# City of Ryde Submission

**For Modification 5 of SSD-5093  
6 Halifax Street, Macquarie Park  
(Lot 117, DP 1224238)**

**Submission Date: 31 August 2022**

Figure1. Proposed changes regarding land zoning in Housekeeping Review Planning Proposal 2022

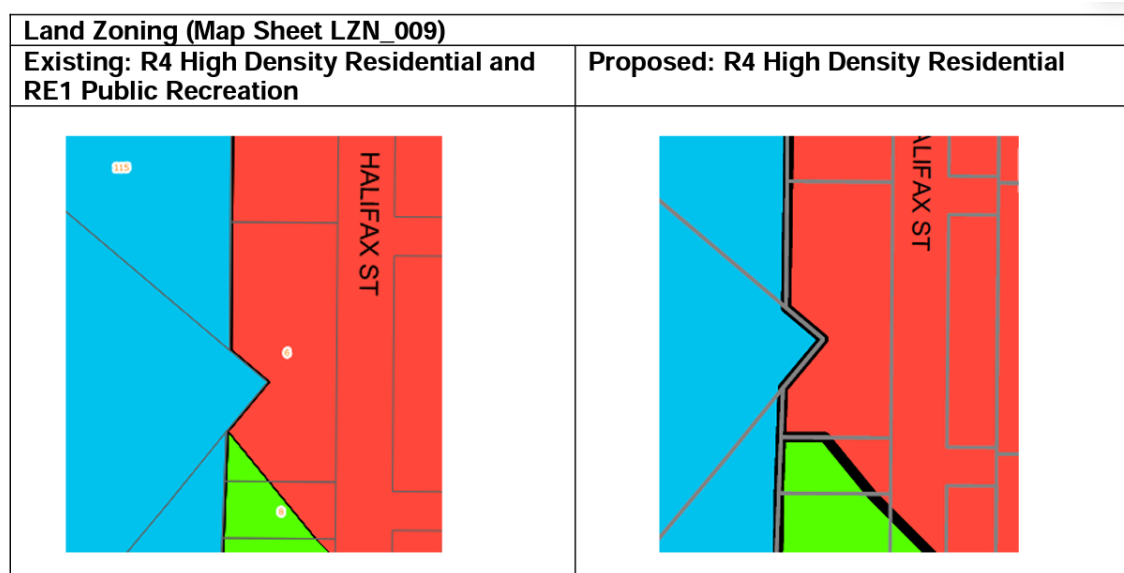
The Planning Proposal includes the rezoning of a small portion of land zoned 'RE1 Public Recreation' to 'R4 Low Density Residential' on the subject site to correct a zoning anomaly. It also seeks to apply a floor space ratio (FSR) of 3:1 and maximum height of 75 meters across the whole site to be consistent with the remainder of the site (refer to Figures 1, 2 & 3 below).

The assumptions used for FSR calculation in Table 2 of the submitted Statement of Environmental Effects (SEE) are inconsistent with the above exhibited Planning Proposal. Based on the FSR sought by the Planning Proposal, the site will only achieve a base GFA of 7,521m<sup>2</sup>, or a maximum GFA of 9,025m<sup>2</sup> should a bonus of 20% is applied under the *State Environmental Planning Policy (Housing) 2021* (Housing SEPP).

Council staff consider that any increase in the GFA on the site should not exceed the maximum permitted GFA under the RLEP 2014 to maintain an appropriate density relationship with existing and future developments in Lachlan's Line. Therefore, subject to 100% of the GFA being used for affordable housing, it is recommended that the amended GFA on Lot 117 for this SSD modification is to be capped at 9,025m<sup>2</sup>. Should any additional GFA be sought on the site, it can be considered at the future Development Application (DA) stage provided that the Applicant is able to demonstrate sufficient design merits through Clause 4.6.

Figure2. Proposed changes regarding floor space ratio in Housekeeping Review Planning Proposal 2022

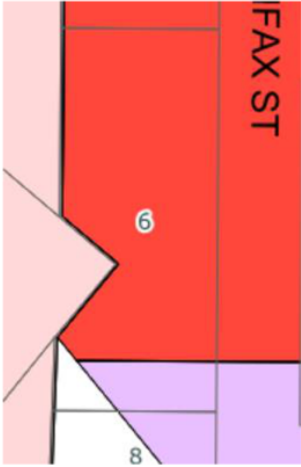
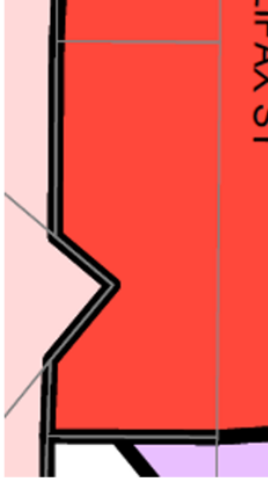
Floor Space Ratio (Map Sheet FSR_009)	
Existing: Maximum floor space ratio of 3:1 and 4.3:1	Proposed: Maximum floor space ratio of 3:1

Figure 4. Subject site's relative location to the Wicks Road South (Garungul) neighbourhood

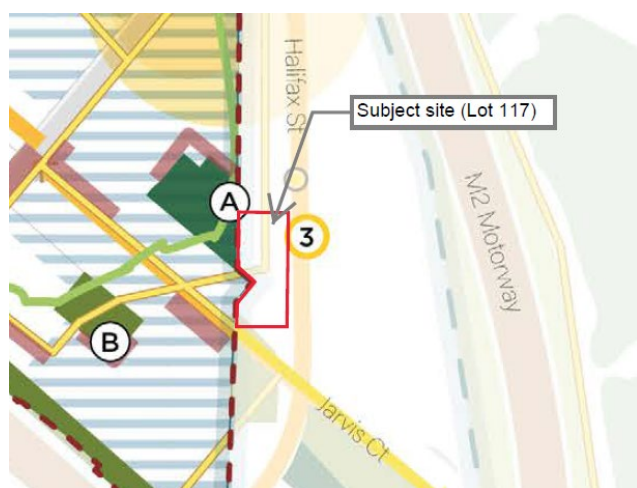
The proposed modification should take into consideration the increased overshadowing impact on the proposed future 'Corridor Square' (labelled 'A' in Figure 4) located immediately to the west of the site and also its implications on a fine-grained pathway (represented by a yellow line in Figure 4) appeared running through the northern portion of the site.
